AGENDA Village of Chenequa Monday, April 14, 2025 31275 W County Road K, Chenequa, WI 53029

To: Plan Commission, Village of Chenequa

Subject: Site Plan Review

Project Description: Primary Residence and Landscape Plan

Landscape, Grading and Lighting Plan

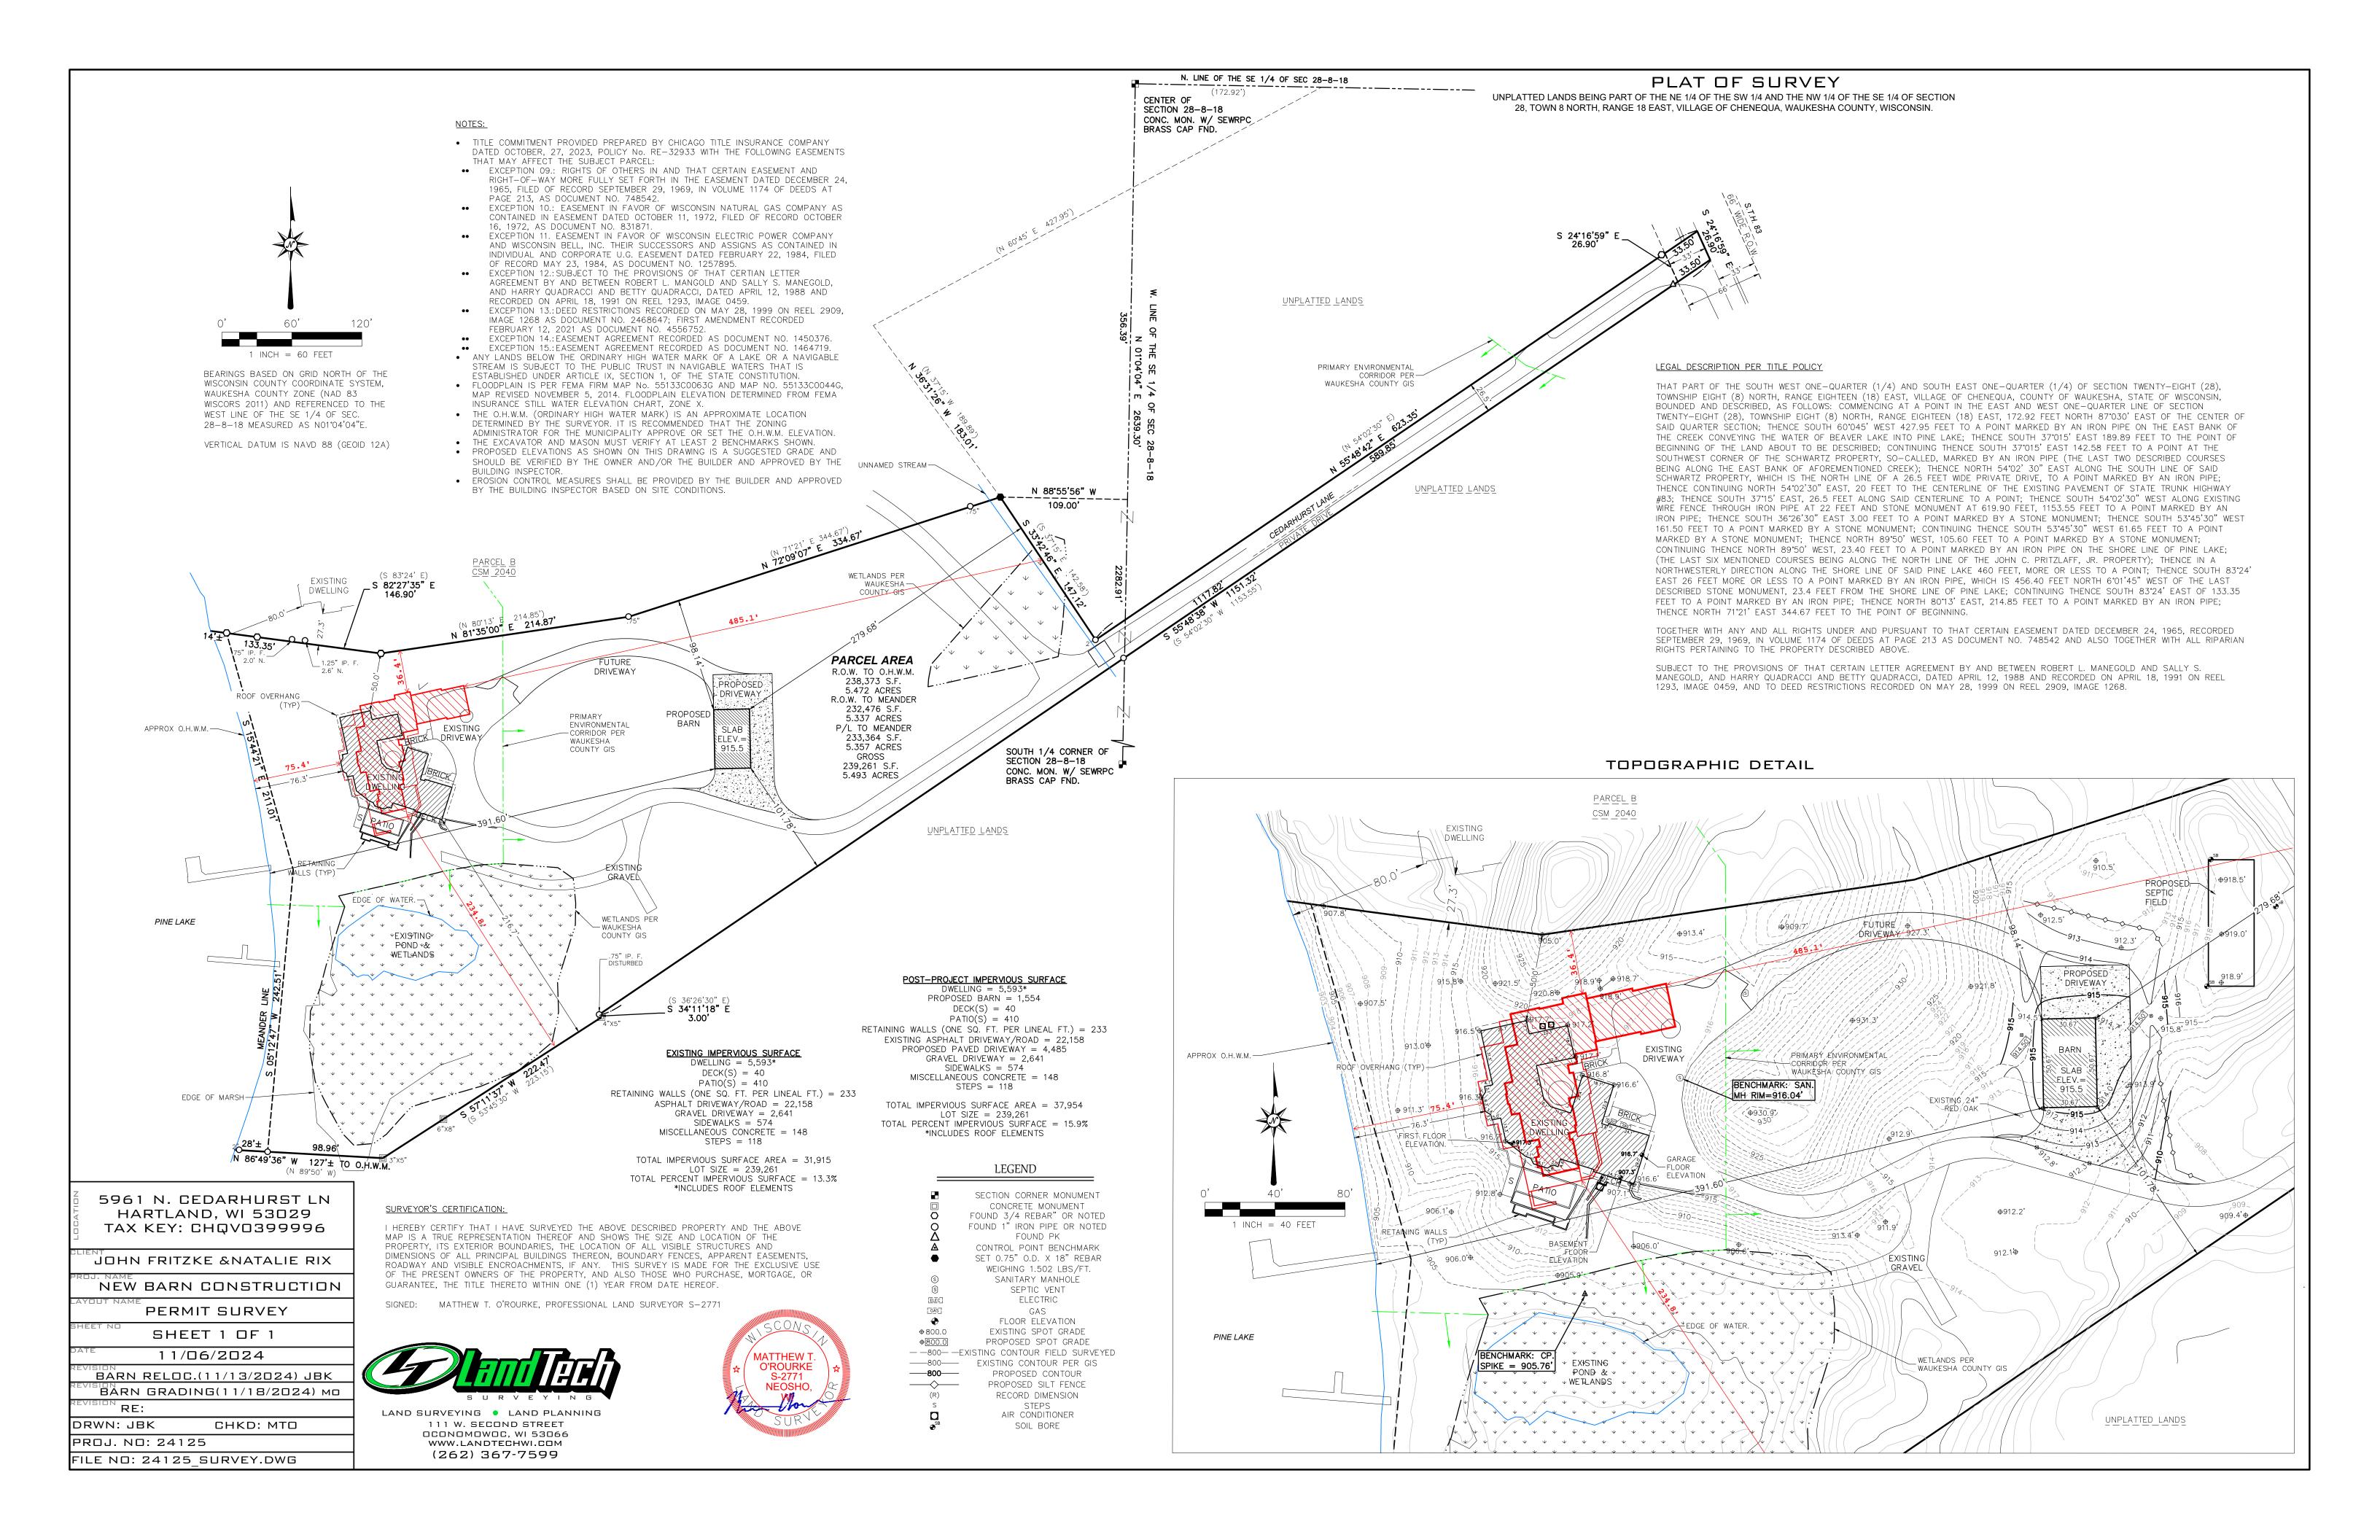
- 1. LandWorks has submitted a landscape/driveway plan on behalf of the Fritzke/Rix family. These plans include;
 - a. A proposed new driveway layout
 - i. The current driveway terminates at the existing residence.
 - ii. As presented on provided plans; the new driveway will create a large loop
 - iii. The driveway addition will cut through a ridge which will require a significant amount of grading and the installation of retaining walls.
 - 1. At the highest point, the applicants propose to reduce the elevation

- approximately 10' to accommodate for the new driveway.
- 2. Each of the proposed retaining walls shown on provided plans will be 2-5' in height.
- iv. The proposed driveway addition is relatively flat. The pitch does not exceed the maximum 12% requirement.

- iii. Location of these patios can be found on the provided landscape grading and lighting plan
- c. Driveway Apron
 - i. The driveway apron near the dwelling will be a mix of natural stone pavers and asphalt.

- iii. These retaining walls do not encroach on the minimum side yard setback requirements.
- e. Stairs
 - i. The landscape plan proposes several sets of stairs that connect the lakeside patio and driveway to the lake path. These stairs are beyond the 75' shoreland setback.

- a. Around the perimeter of the home the applicant will be installing a series of 12" catch basins. These catch basins are proposed to tie into drain tiles which are proposed to extend from the house and terminate at "daylight". The location of these drains is indicated on the provided drainage diagram.
- 3. Proposed Landscape Lighting
 - a. The landscape plan also proposes 18 fully shielded pathway lights around the property.
 - i. A spec sheet for the proposed landscape light is provided in the packet
 - ii. The proposed lumen output per fixture is 93
 - iii. The color temperature of these fixtures is 2,700K
- 2. A man-made pond exists on the property and falls within 75' of the proposed dwelling

- 8. If the Village Board determines the building site grading plan needs further review for storm water management, a storm water and grading plan shall be reviewed by an engineer of the Village's choice and paid for by the applicant.

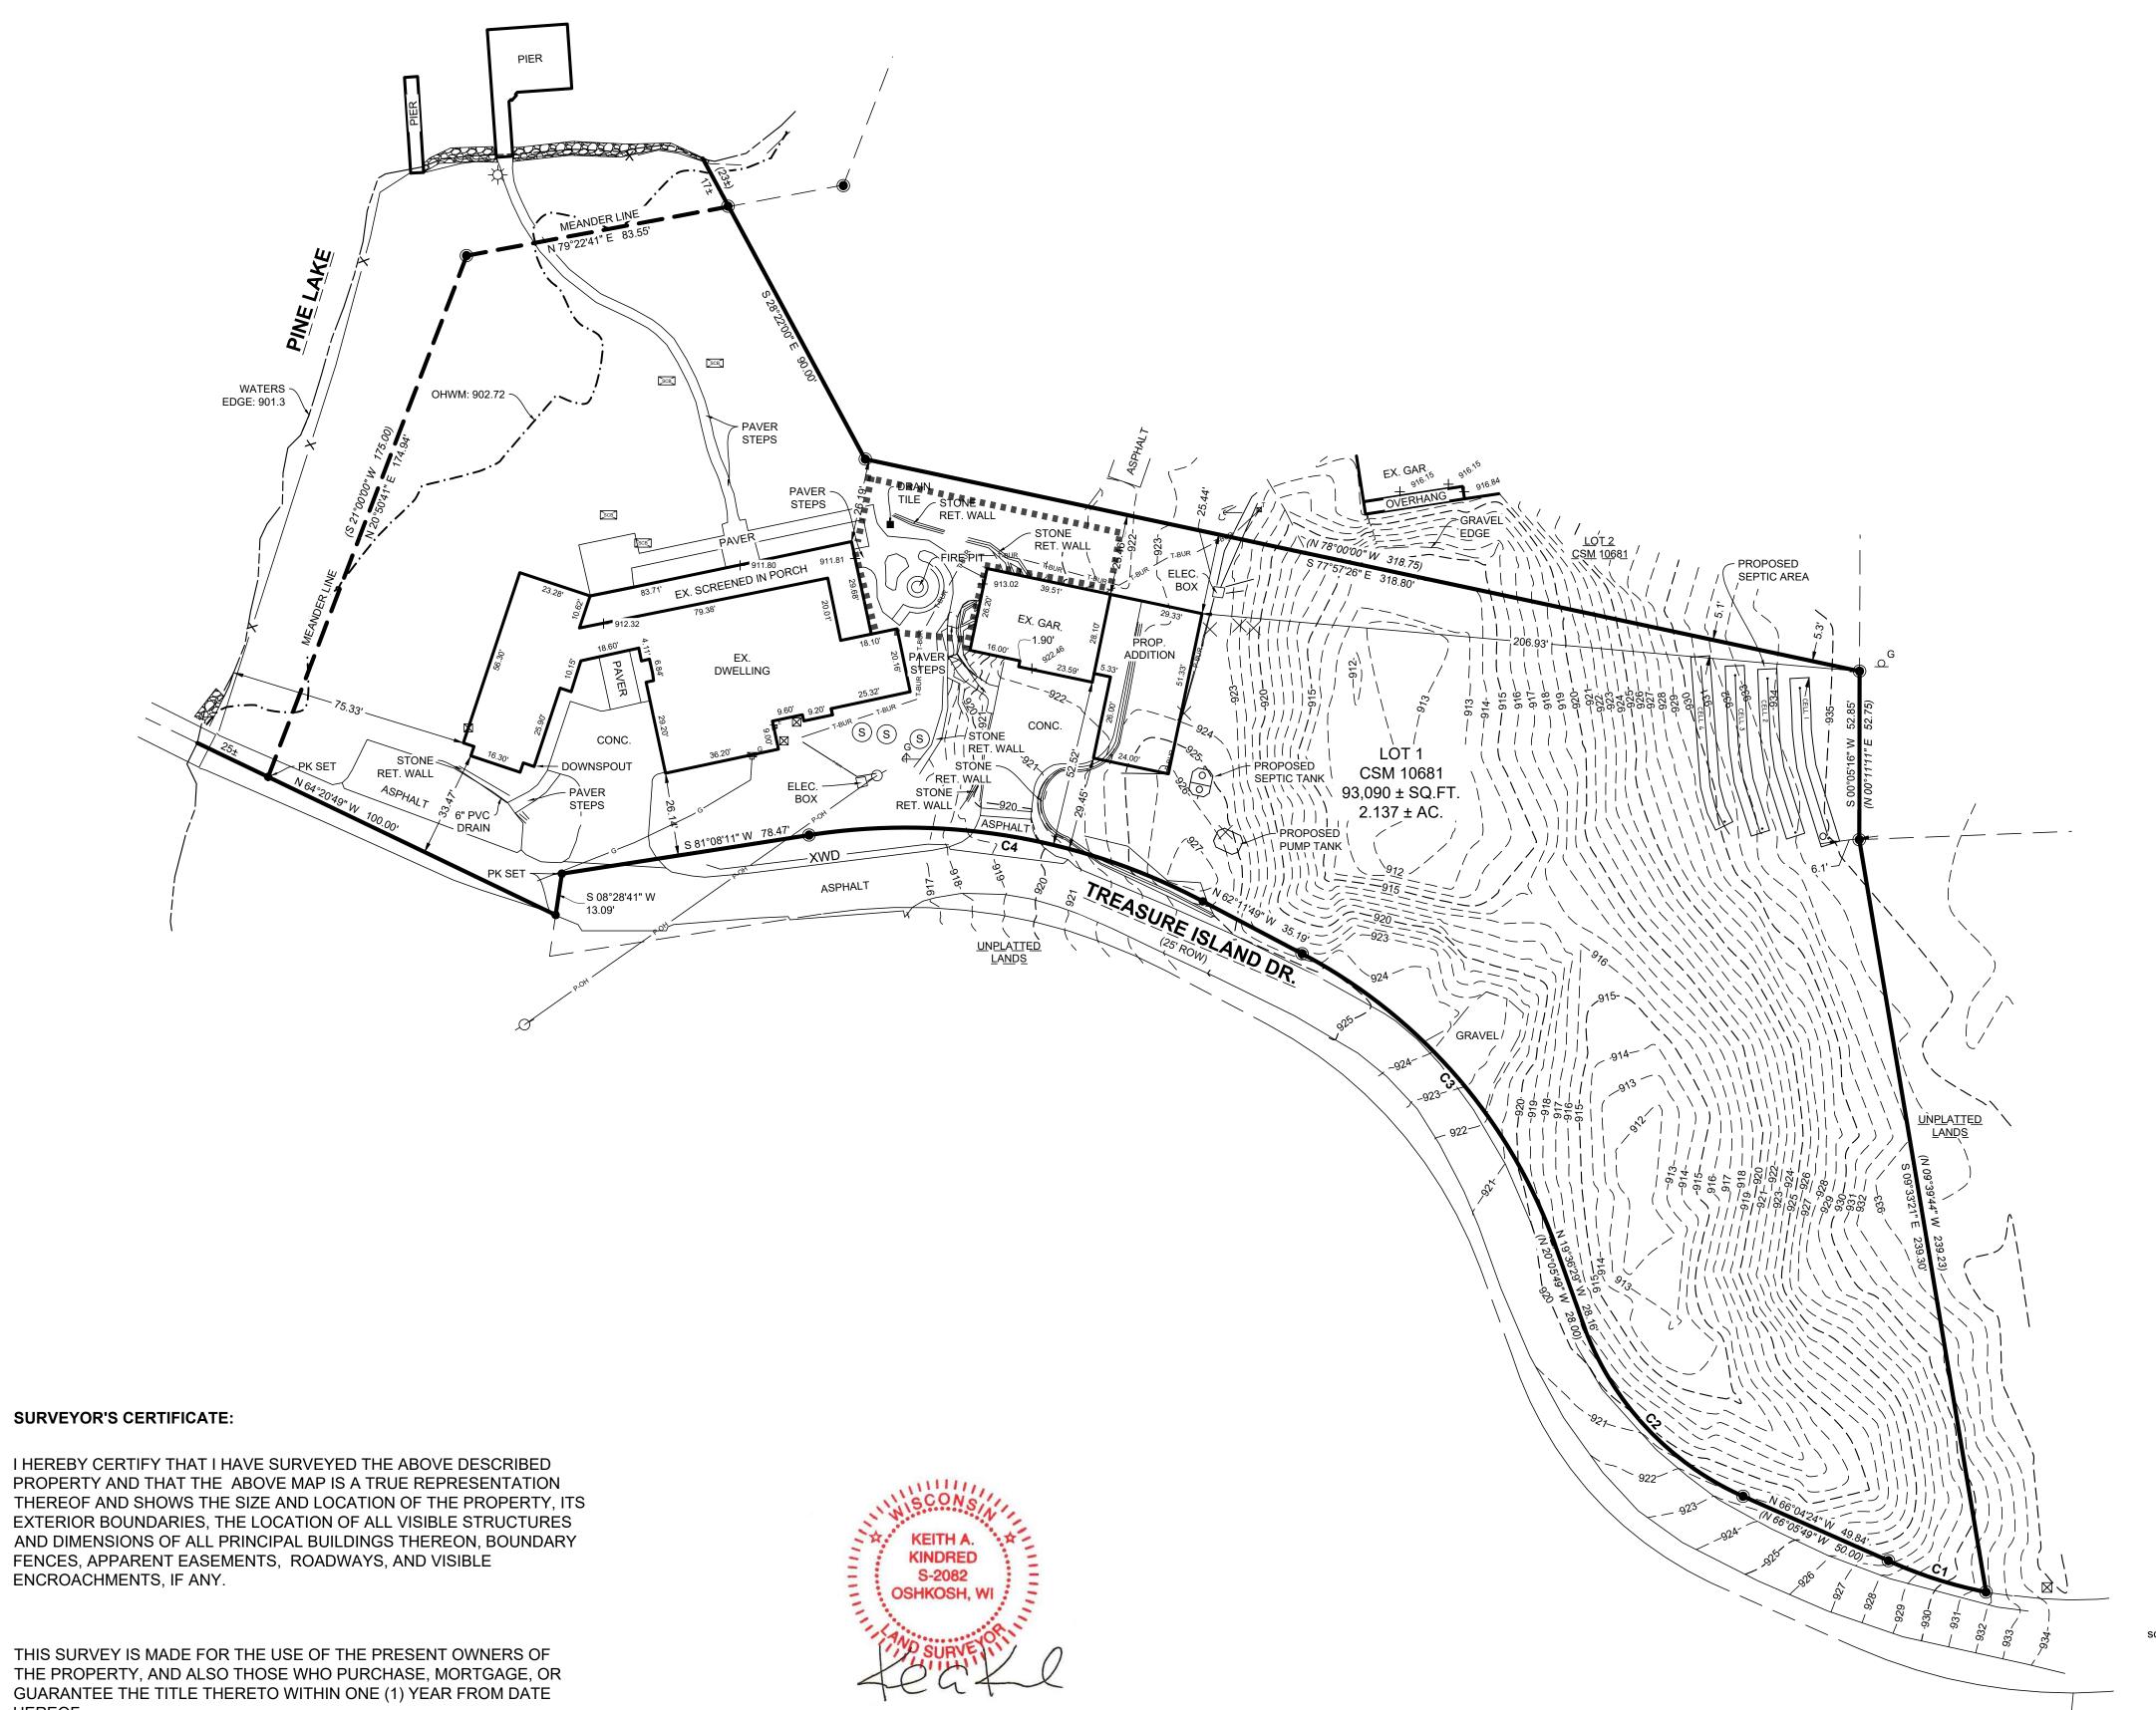
- 1. LandWorks Inc. has submitted a landscape plan that has been prepared on behalf of Pine Cove Hollow. The plan proposes the following;
 - i. Fieldstone retaining walls

- 3. Wall locations are provided on landscape plan
 - 4. Retaining walls proposed do not exceed 4' in total height
 - ii. Flagstone stepper pathway on the south side of the house

- 3. Stepper location is provided on landscape plan
 - iii. Flagstone patio on the east side of the garage
 - 1. Patio layout and location is provided on landscape plan

- 2. The applicants propose to use "outcropping steps"
 - 3. Stair location is depicted on the provided landscape plan
- v. Install two standby generators

- 1. There are two proposed standby generators. One that will power the primary dwelling and one that will power the accessory structure.
 - 2. The proposed generator location for the accessory structure is shown on the landscape plan and on the site-plan provided by the Vector Electric.

- 3. The generator location for the primary residence is provided on the site plan provided by Vector Electric.
- 2. According to 6.9(2)(d) a grading permit must be issued by the Village of Chenequa Zoning Department before work may begin.
